Access Compliance Report Public Rights-of-Way (Curb Ramps)

Main Street: GREENBRIER_RD Cross Street: NEWPORT_BLV Location: N

ADA ID: RPRK211012145312 Ramp Type: Type 4 - Parallel Initial Pass/Fail: Fail Overall Compliance: No Severity Score: 16

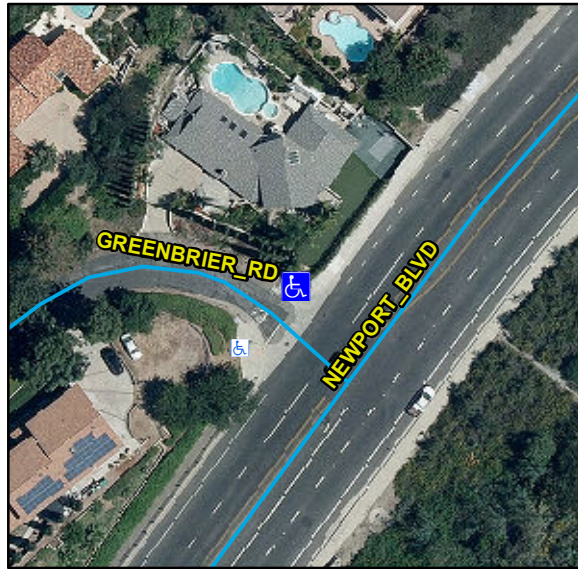
Compliance	Description	Data	Compliance	Description	Data
N/A	Ramp Length LT (in)	64	N/A	Ramp Length RT (in)	96
Yes	Ramp Width LT (in)	96	Yes	Ramp Width RT (in)	96
No	Ramp Run Slope LT (%)	10.8	No	Ramp Run Slope RT (%)	9.8
No	Ramp Cross Slope LT (%)	3	Yes	Ramp Cross Slope RT (%)	2
N/A	Landing Present	N/A	N/A	DWS Provided	N/A
N/A	Landing Length (in)	N/A	N/A	DWS Contrast	N/A
N/A	Landing Width (in)	N/A	N/A	DWS Length (in)	N/A
N/A	Landing Run Slope (%)	N/A	N/A	DWS Full Width	N/A
N/A	Landing Cross Slope (%)	N/A		DWS Offset Type	N/A
N/A	Landing Movement Obstructed?	N/A	N/A	DWS Offset Left (in)	N/A
	Landing Movement Type	N/A	N/A	DWS Offset Right (in)	N/A
N/A	Landing Shared	N/A			
N/A	Clear Space	Yes			
N/A	Clear Space To Crosswalk (in)	N/A			
N/A	Marked Crosswalk 1	No	N/A	Marked Crosswalk 2	No
	Crossing 1 Direction	SW		Crossing 2 Direction	SE
	Marked Crosswalk 1 Width (in)	N/A		Marked Crosswalk 2 Width (in)	N/A
N/A	Ramp Inside Crosswalk 1	N/A	N/A	Ramp Inside Crosswalk 2	N/A

Crossing 1 Slope (%)	4.7		Crossing 2 Slope (%)	0.6
	Crossing 1 Cross Slope (%)	5.7		Crossing 2 Cross Slope (%)	1.8
N/A	Gutter Ponding	N/A	N/A	Curb Slope	9.3
Yes	Gutter Lip Height (in)	0		Road Run Slope (%)	4.1
N/A	Gutter Run Slope (%)	N/A		Road Cross Slope (%)	1.2
N/A	Gutter Cross Slope (%)	N/A	Yes	Perpendicular Joint Present	Yes
Yes	Overall Surface Condition	Acceptable			
	Cross Gutter Present?	Yes		Spandrel Present?	Yes
	Replace Cross Gutter?	No		Replace Spandrel?	No

Remove & Replace Curb Ramp With Two New Directional Ramps or Equivalent.
